**Duke Energy Ohio
Case No. 20-0134-EL-BLN
STAFF First Set of Data Requests
Date Received: May 1, 2020**

**STAFF-DR-01-003
SUPPLEMENTAL**

FIGURE 2.01
OPSB BLN FILING
CUMMINSVILLE PHASE 5B REBUILD PROJECT
DUKE ENERGY OHIO
PROXIMITY TO RESIDENTIAL HOMES MAP

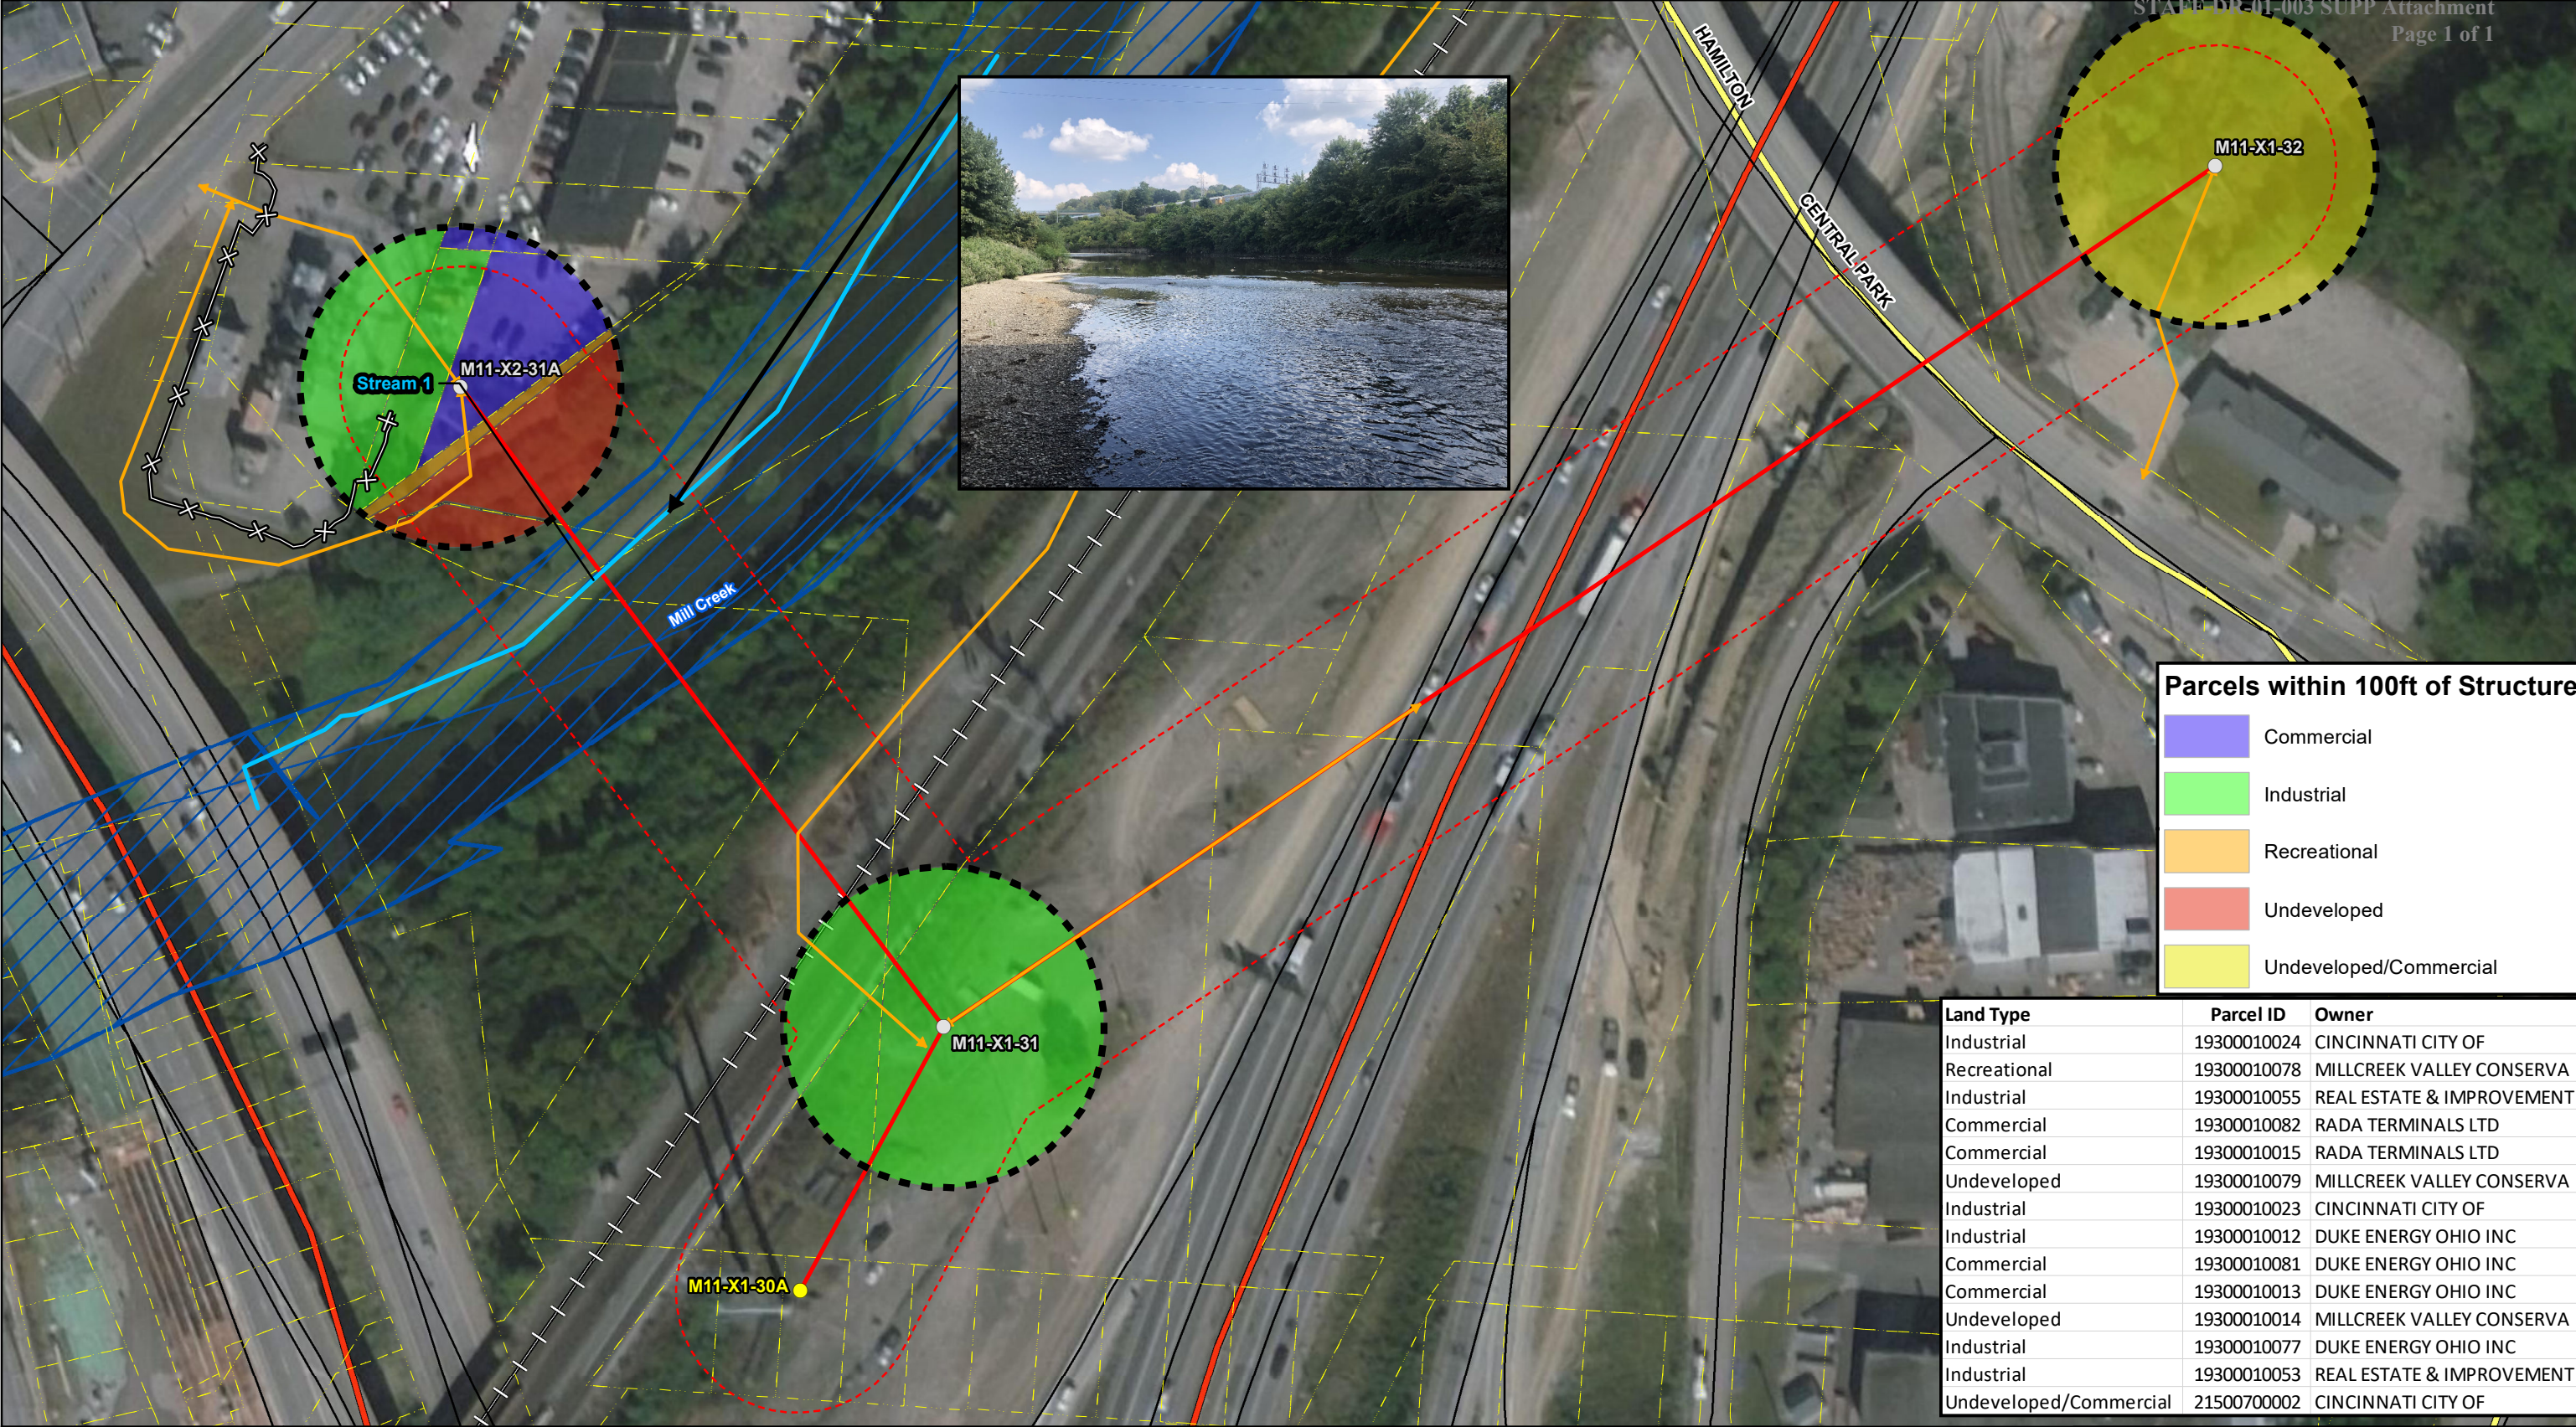
As this case is similar to the 19-1471 case, in terms of ODOT wanting you to relocate due to I-75 improvements, and in light of the residential issues we are dealing with for that one, can you lay out the proximity of the closest structures to homes?

- a. If there are any stub poles?
- b. And how you will handle complaints from residents if they have them as it relates to this project please?

SUPPLEMENTAL RESPONSE: Please see STAFF-DR-01-003 Attachment.
